ATTACHMENT 3

**RESPONSE TO MOECC COMMENTS
RE: LEVEL 1 AND LEVEL 2
HYDROGEOLOGICAL INVESTIGATION REPORT,
PROPOSED FREYMOND QUARRY**

April 3, 2018
MTE File No.: C33886-100

**Response to MOECC Comments
Re: Level 1 and Level 2 Hydrogeological Investigation Report,
Proposed Freymond Quarry**

Scale (11x17) 1:4,000	MTE Project No. 33886-100	Date Apr 2018	Figure No. 1
--------------------------	------------------------------	------------------	-----------------

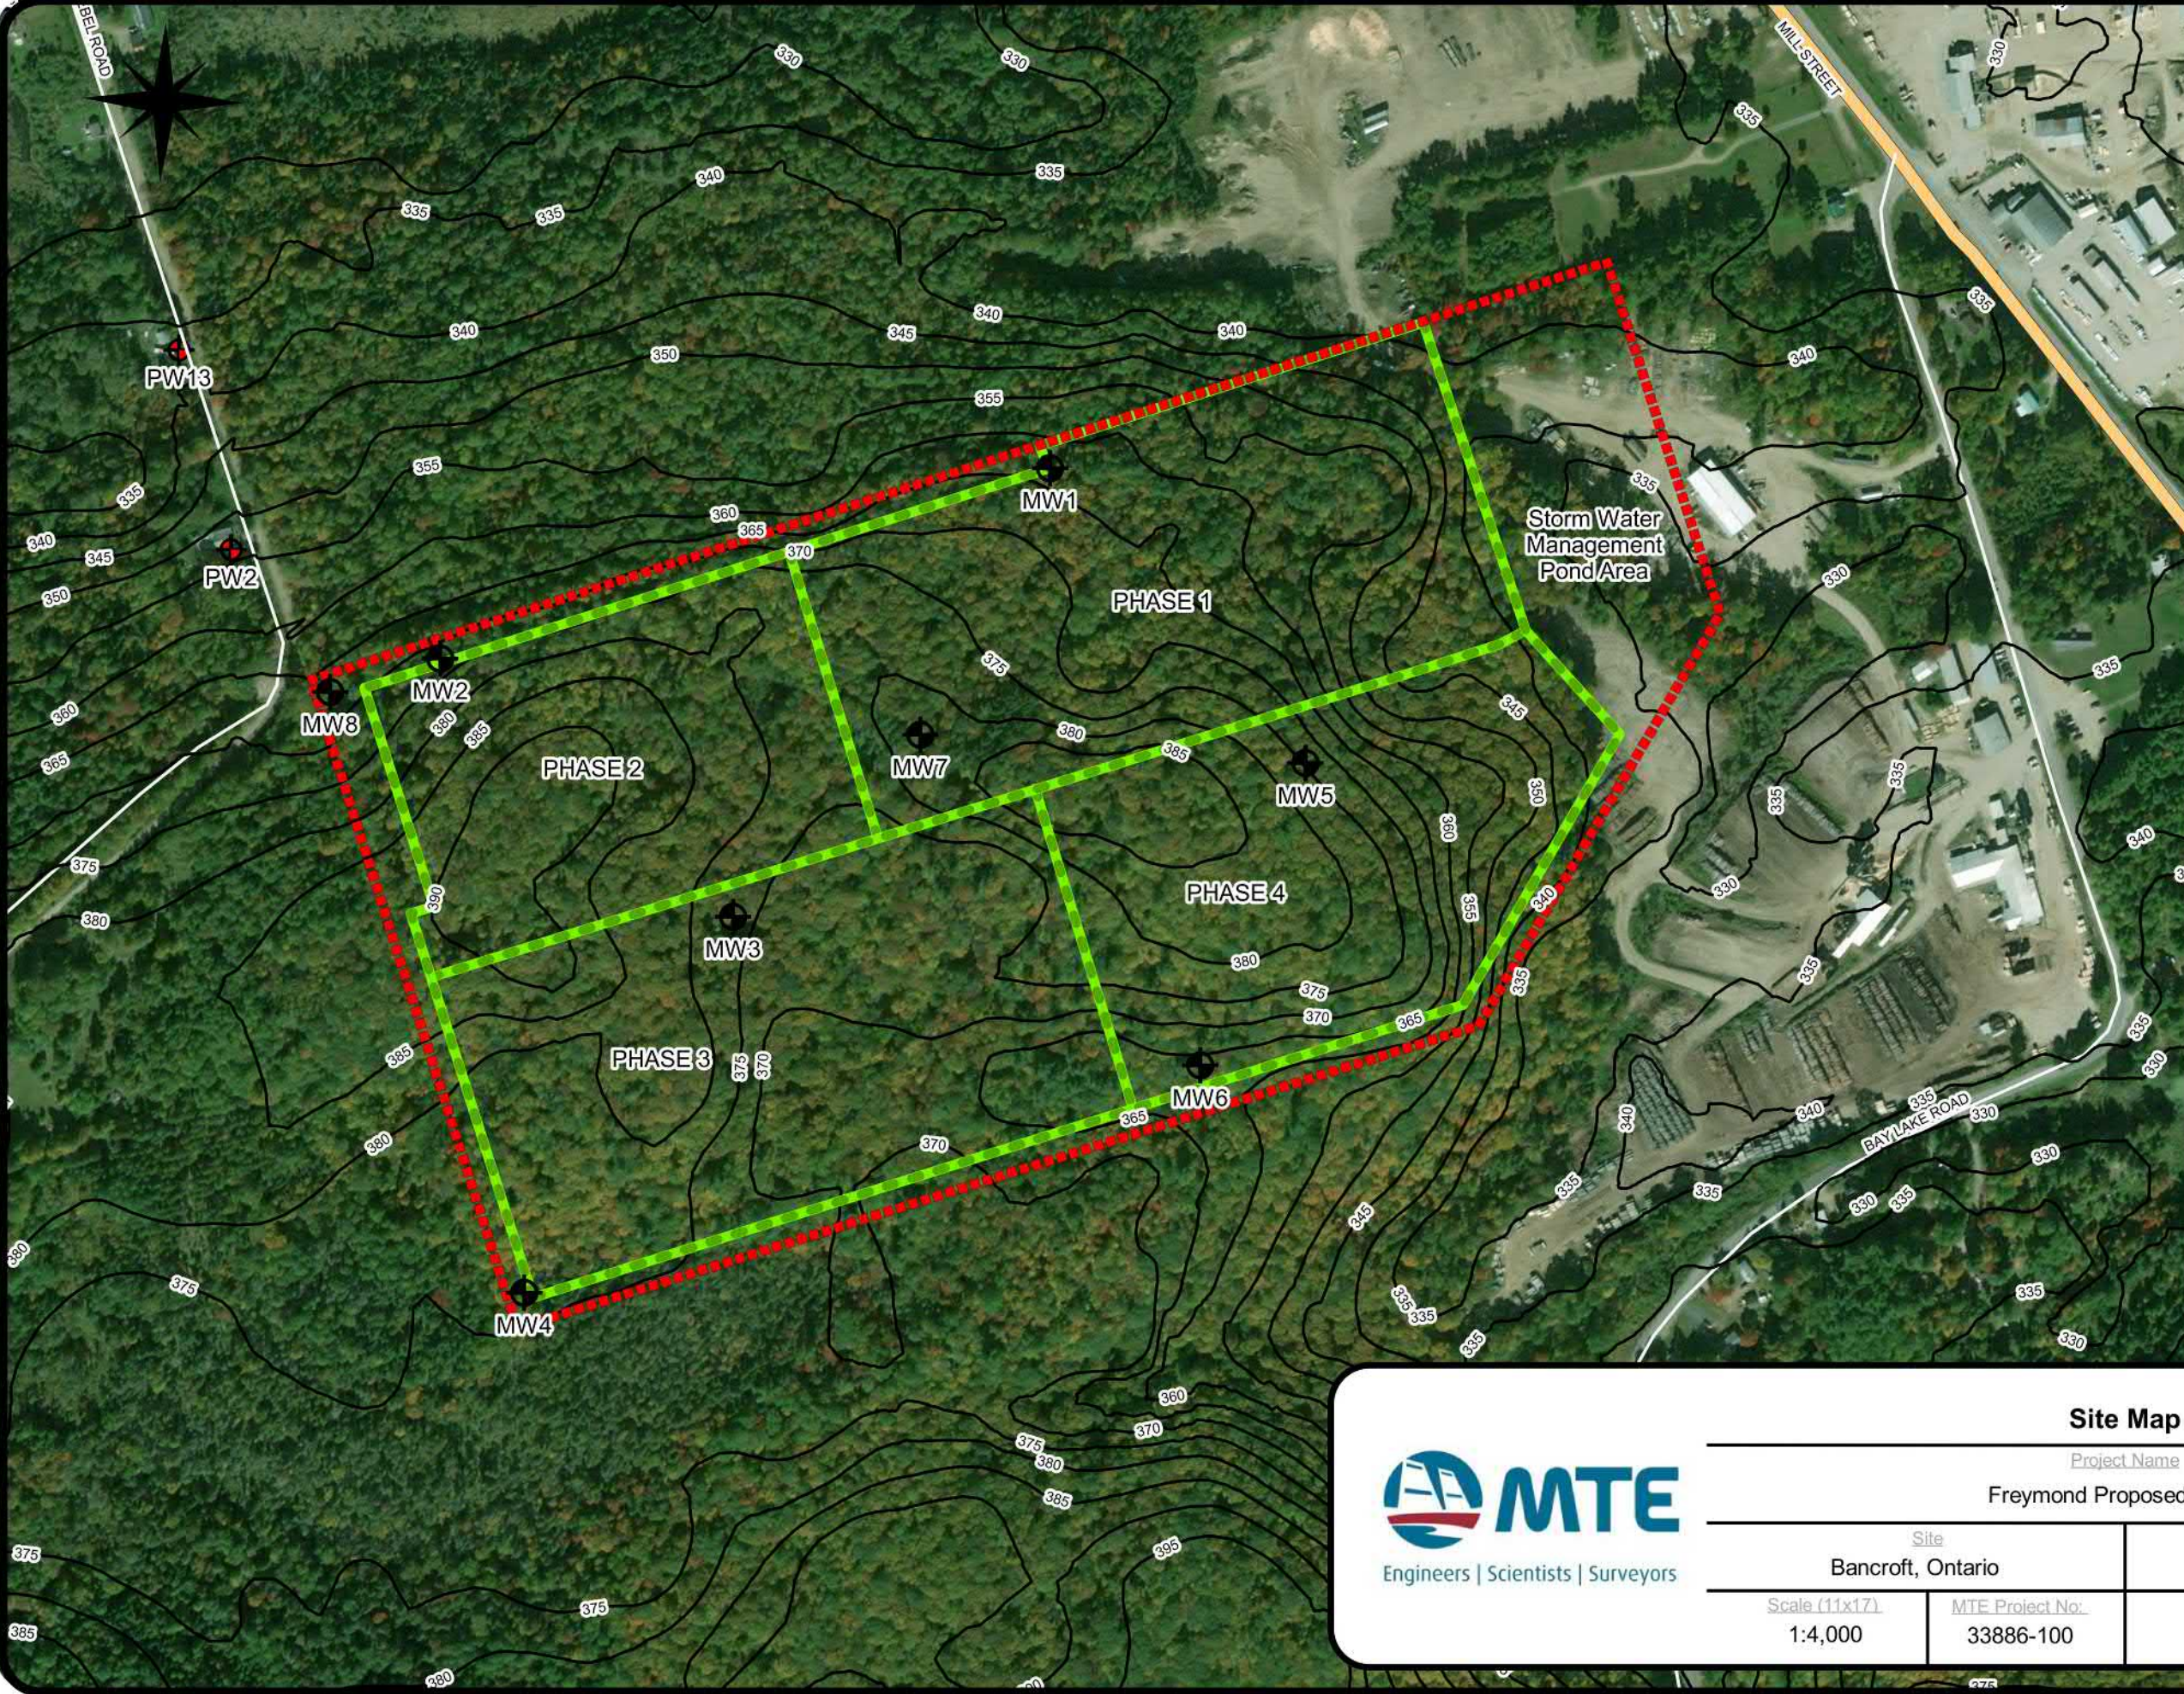
The MOECC inquired as to the extent of fractures that the quarry may intersect and as to whether these fractures are connected to private water supplies. The pumping tests conducted on MW7 and MW8 indicate that fractures are random and discontinuous across the Site and of limited aerial extent. In addition, pumping at MW8 which is located at the northwest corner of the Site did not affect the two closest off-Site receptors to the Site.

Responding to comments received by the MOECC, MTE endeavored to conduct a 24 hour pumping test on MW7 and MW8 as seen on **Figure 1**. The purpose of this pumping test was to determine aquifer properties, evaluate the sustainable yield of each well, and identify any impacts related to pumping.

Prior to, during, and post pumping at MW7 and MW8, water levels were measured at 16 monitoring locations which are outlined below and can be seen on **Figure 1**.

Based on the results of the pumping tests neither MW7 nor MW8 was capable of sustaining a pumping rate greater than 35L/min (~ 50,000 L/day). MTE maintains that a Permit to Take Water will not be required to manage groundwater discharging into the quarry at a rate higher than 50,000 L/day. Further, we maintain that the potential impact of the quarry post extraction has been appropriately assessed by MTE utilizing the analytical methods described in the 2016 Level 1 Level 2 Hydrogeological Investigation Report, and supporting documentation provided to the MOECC by MTE in our correspondence with the MOECC documented herein.

<i>Scale (11x17)</i>	<i>MTE Project No.</i>	<i>Date</i>	<i>Figure No.</i>
1:4,000	33886-100	Apr 2018	1

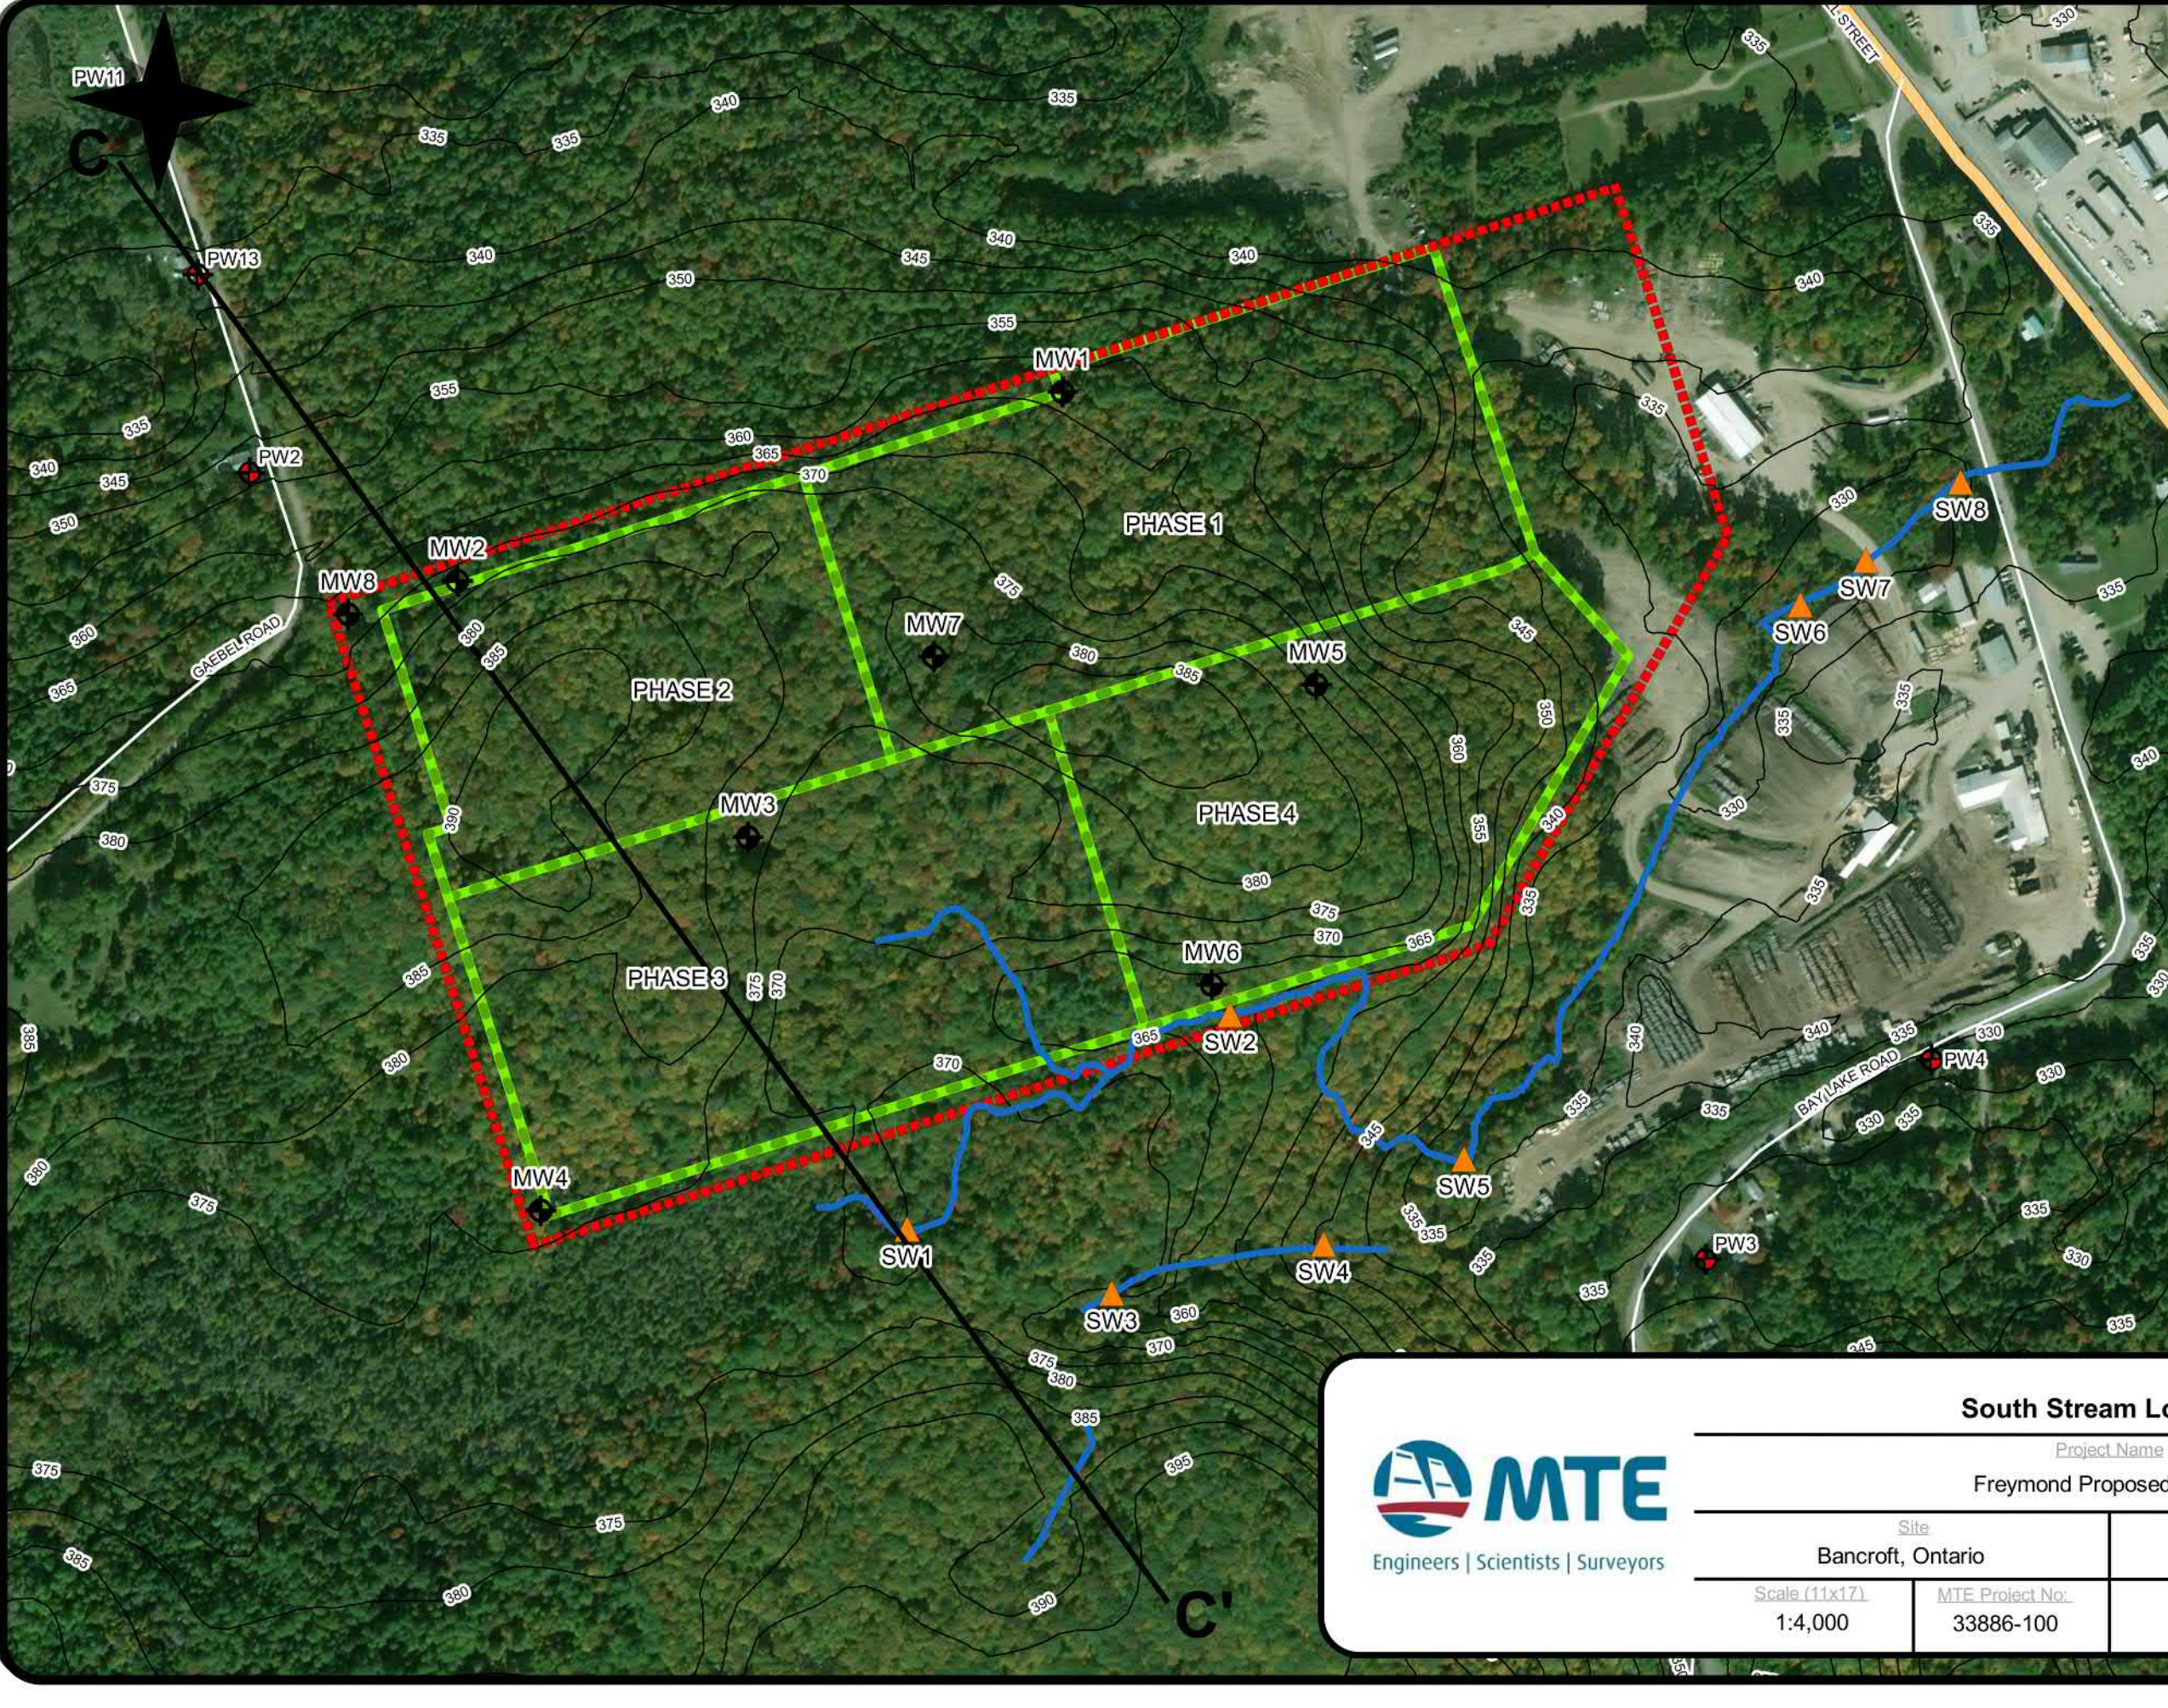
The Greer Galloway Group Inc. hereby referred to as “Greer Galloway” was retained by the County of Hastings to carry out a peer review of MTE’s Level 1 and Level 2 Hydrogeological Investigation for the proposed Freymond Quarry. This technical memo is intended to provide additional information related to comments received from Greer Galloway regarding the South Stream.

Survey data indicated that the headwaters of the South Stream originate west of Phase 3 (**Figure 1**). From SW1 the South Stream flows northeast and then east roughly along the licensed boundary. Approximately 35 m southwest of the Phase 3/Phase 4 boundary, the South Stream is joined by a tributary whose headwaters originate in Phase 3. The South Stream then flows east between the licensed and extraction boundary for approximately 185 m before flowing south towards SW5.

In the fall of 2017, MTE initially focused on determining if the stretch of the South Stream between SW5 and SW7 (**Figure 1**) was recharging water into an underlying aquifer. This was completed by measuring flows at SW5, SW6 and SW7. The location of SW5 was chosen as it is upstream of the Freymond Lumber yard. SW6 and SW7 were chosen as SW6 is upstream of the proposed outlet for the SWM facility while SW7 is downstream of the proposed outlet.

Based on the setbacks as indicated on the Operational Site Plans (**Attachment 1**) the main branch of the South Stream will remain intact throughout and post extraction (**Figure 1**). Following the extraction of Phase 3, any flow originating within Phase 3 will no longer contribute to the main branch of the South Stream and instead will be directed toward the SWM Facility and will ultimately flow back into the South Stream. Water originating at the headwaters of SW1 will continue to flow downstream to SW5.

Scale (11x17)	MTE Project No.	Date	Figure No.
1:6,000	33886-100	Apr 2018	4

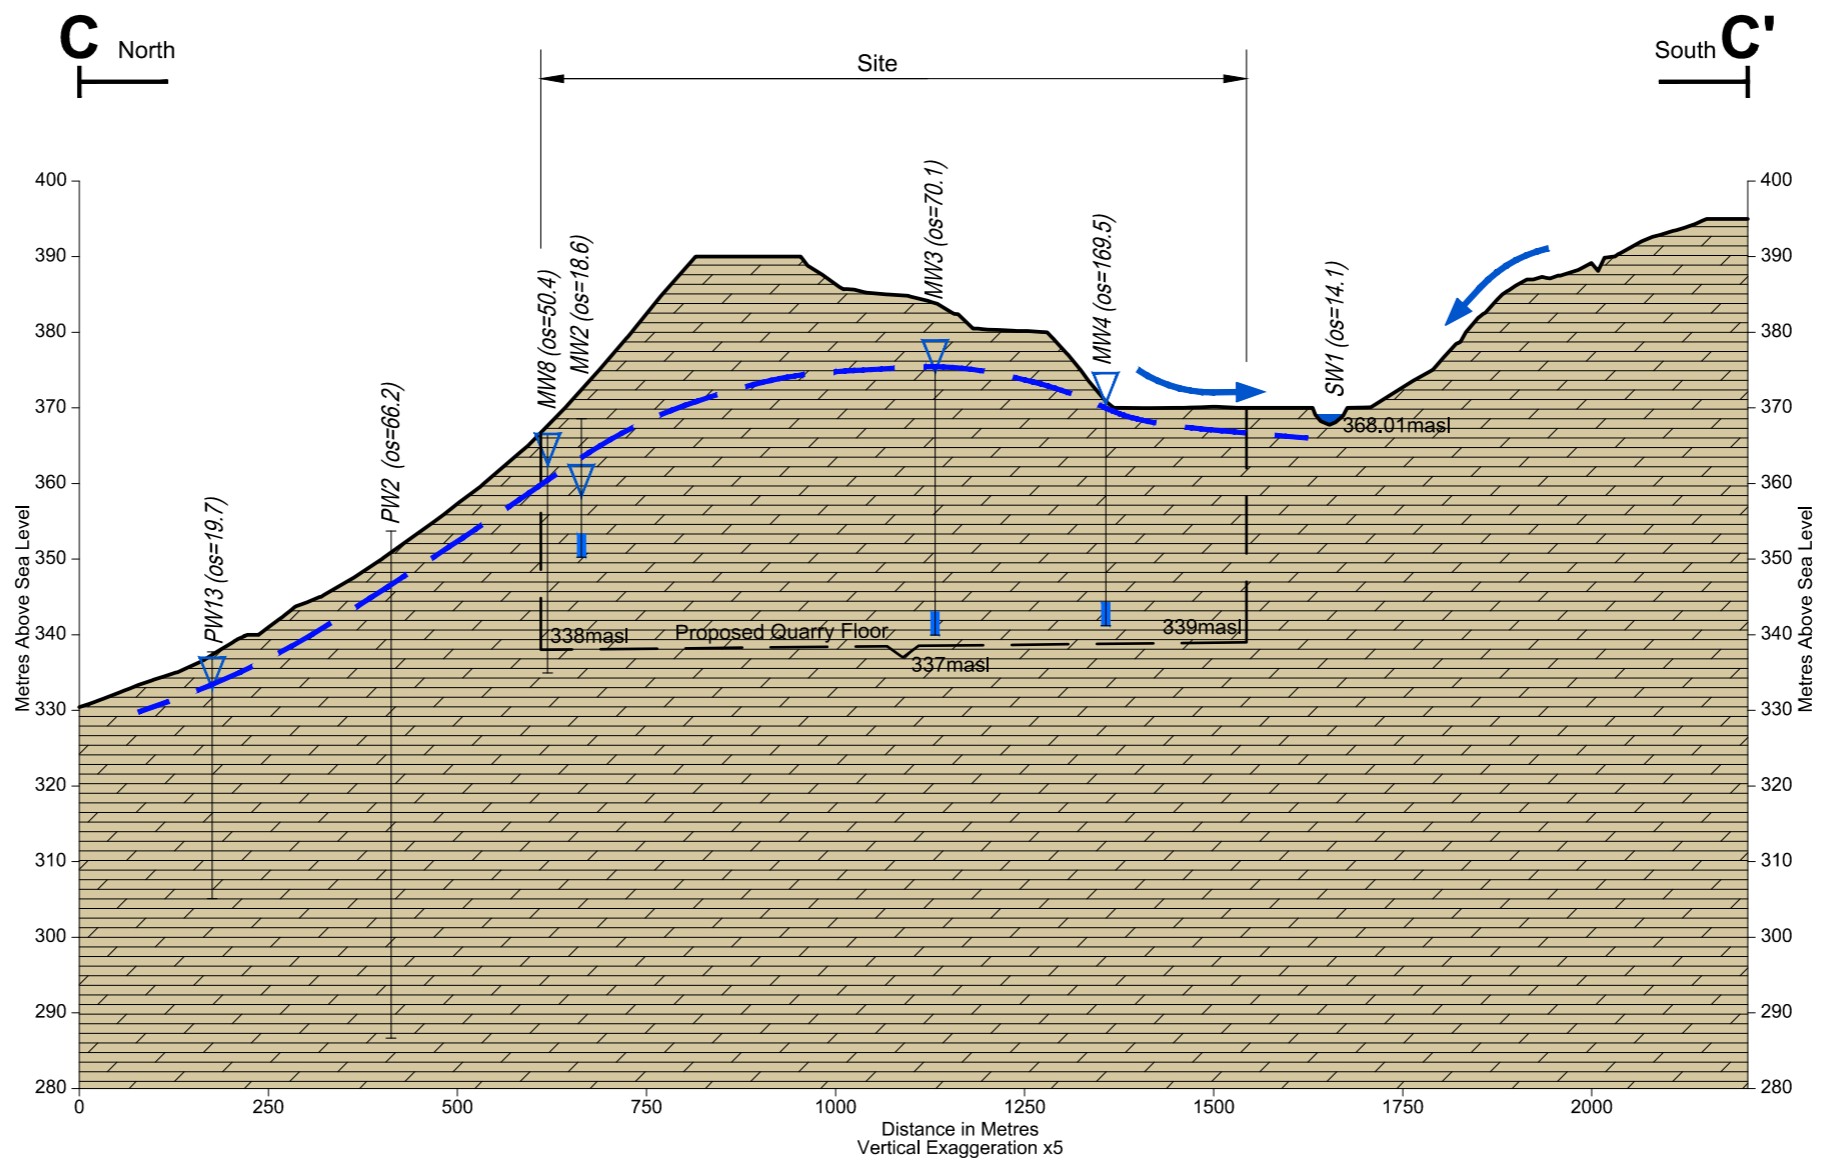
In addition to the above, MTE has assessed the catchment area of SW1 to better understand the groundwater contribution to the headwaters of the South Stream. The catchment area was mapped using contours obtained from Ontario Base Maps (OBM) and can be seen in **Figure 4**. A summary of the catchment assessment is presented in **Table 3**.
